NUMBER: 21-002-07 REV. B

GROUP: Transmission

Flash: Torque Converter Shudder / Shift Quality Improvements / DTC P0732

This bulletin involves reprogramming the Powertrain Control Module (PCM) with new software and replacing the torque converter as required.

Fig. 1 AUTHORIZED MODIFICATION LABEL

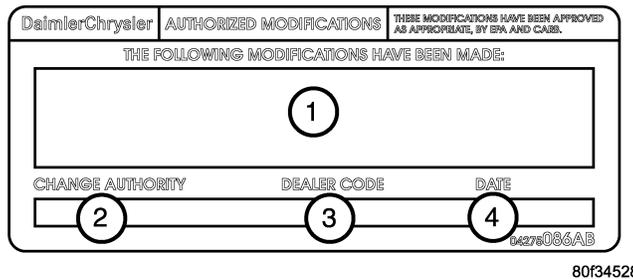
- 7. Type the necessary information on the “Authorized Modification Label” p/n 04275086AB and attach near the VECI label (Fig. 1).

- 1 - POWERTRAIN CONTROL MODULE P/N (INSERT P/N) USED
 - 2 - CHANGE AUTHORITY: TSB XX-XXX-XX
 - 3 - DEALER CODE: XXXXX
 - 4 - DATE: XX-XX-XX
-
